GS/AAH/4632/12

17 September 2012

**RE : NEW END, HAMPSTEAD – DAYLIGHT & SUNLIGHT IMPACT TO LAWN HOUSE**

3D VIEW  
LAWN HOUSE  
BASEMENT WINDOW MAP

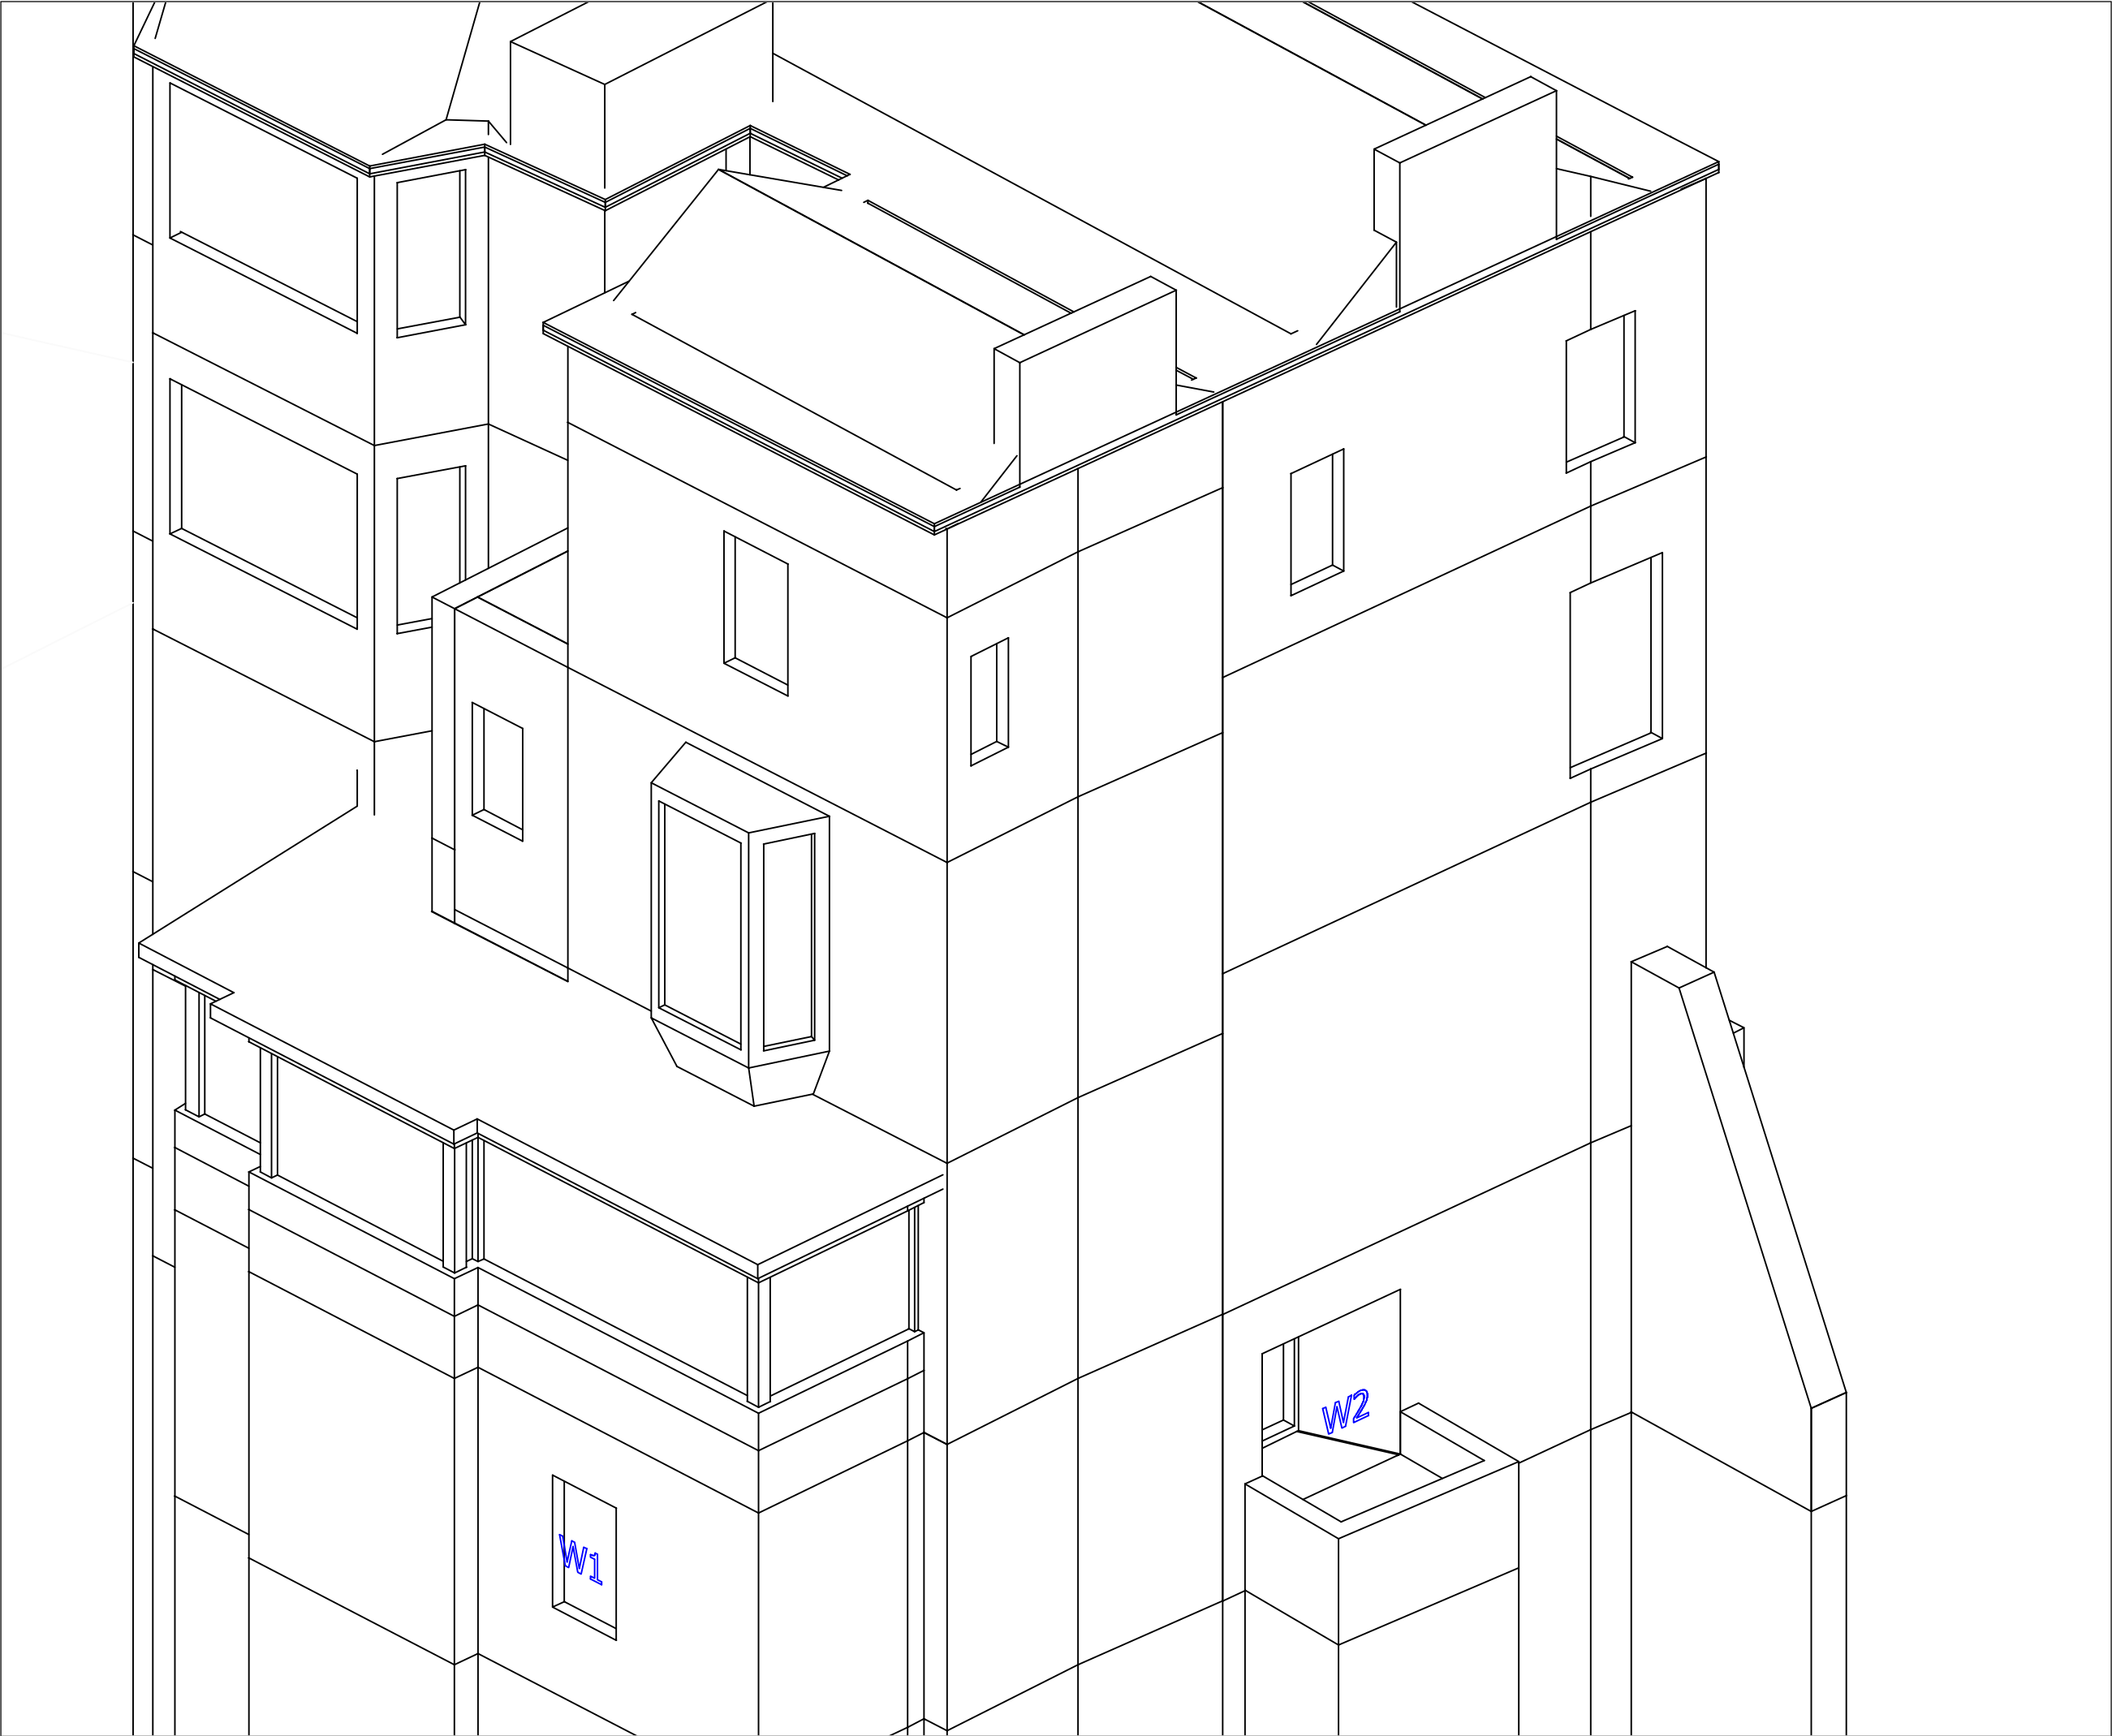
Following our discussions and receipt of the comments from the London Borough of Camden in respect of the current planning application for New End, Hampstead, please find enclosed our response in respect of those comments which were received via email on 30<sup>th</sup> August 2012.

Following receipt of the description of the internal layout of the basement room (R1/200), we have updated our analysis in respect of this room and provide a summary of this updated analysis below.

Our updated analysis is based on the description of the basement room provided by the planning officer which includes a rear south facing window overlooking the garden, a front north facing window in a narrow lightwell and a smaller east facing window on the boundary with 29 New End. A window map showing the location of these windows is enclosed. Unfortunately, we have been unable to obtain photographs of this room and therefore, our updated analysis is based entirely upon the description provided by LB Camden.

Following the updated analysis of this room layout, we have provided 2 additional windows to this basement room (W1/200, W3/200) whilst retaining the previously assessed flank window (W2/200). The updated results are enclosed.

The updated daylight analysis of this room shows that the proposed scheme will not have an impact to the VSC levels of the two additional windows assessed beyond that recommended by the BRE. The results indicate the same impact to the previously assessed flank window although this impact is discussed in our main report.

In respect of ADF, the results show the proposed scheme will have an impact upon room R1/200. The reduction in ADF as a result of the proposed scheme is low and will not be noticeable (5.48%). As such, the impact is considered acceptable.

In summary, GIA have updated the basement room layout of Lawn House (R1/200) following receipt of comments from the London Borough of Camden. Having analysed the updated room layout, I can confirm that there are no additional impacts to the room as a result of the proposed scheme beyond that recommended by the BRE. Therefore, the impact to the updated room is considered acceptable in respect of the BRE guidelines.
